MARSTON PLACE SUBDIVISION, RE-SUBDIVISION OF LOT 5 & PART OF LOT 6

APPLICATION NUMBER 5 DATE December 1, 2011

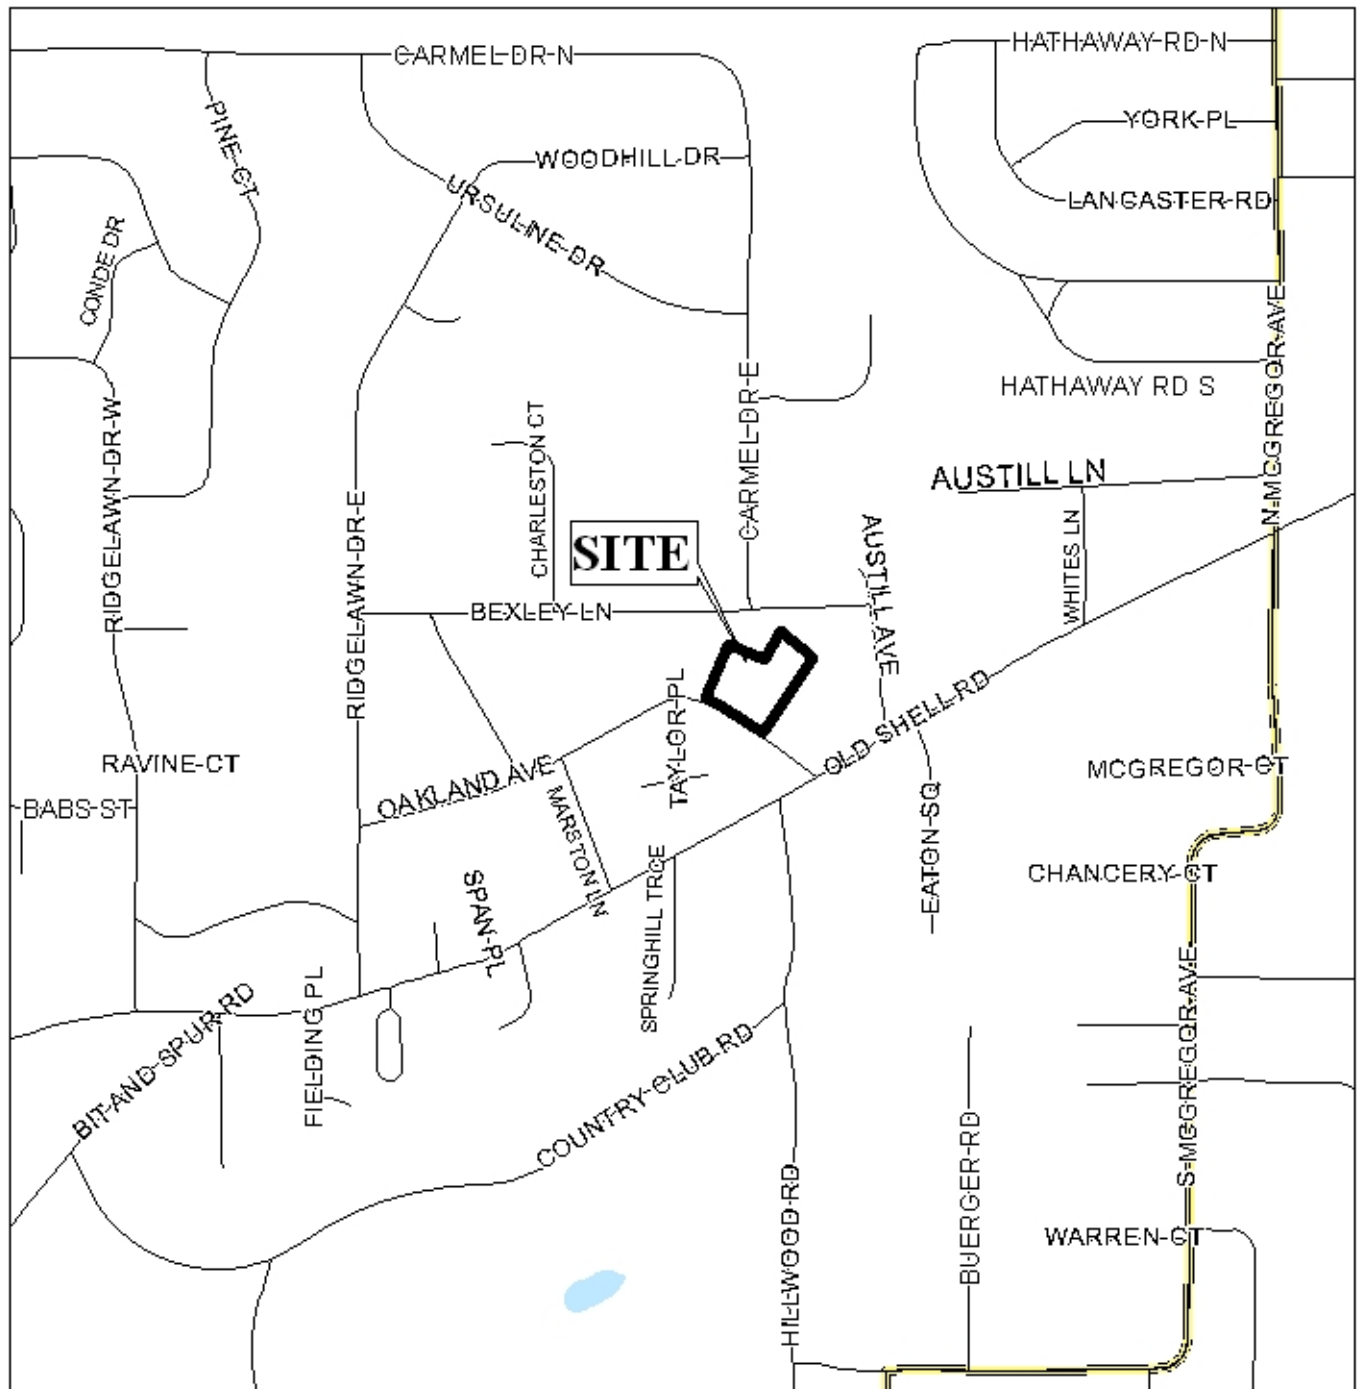
Each lot meets the minimum area and width requirements of the Subdivision Regulations; however, the size of Lot B is mislabeled on the preliminary plat with respect to the size in square feet. As on the preliminary plat, the Final Plat should also label each lot with its size in both square feet and acres, revised for the correct Lot B square footage, or a table should be furnished on the Final Plat providing the same information. The 25' minimum building setback line should also be illustrated on the Final Plat as on the preliminary.

The Final Plat should also indicate the compliant side yard setback off the new property line for the existing carport along the West side of proposed Lot B.

- 1) placement of a note on the Final Plat stating that each lot is limited to one curb cut to Oakland Avenue, with the size, design and location to be approved by Traffic Engineering and conform to AASHTO standards;
- 2) labeling of each lot with its size in acres and square feet, with the correction of the size in square feet for Lot B, or the furnishing of a table on the Final Plat providing the same information;
- 3) illustration of the 25' minimum building setback line on each lot;
- 4) illustration of a compliant side yard setback for the carport on the West side of Lot B; and
- 5) placement of a note on the Final Plat stating that development of this site must be undertaken in compliance with all local, state, and Federal regulations regarding endangered, threatened or otherwise protected species.
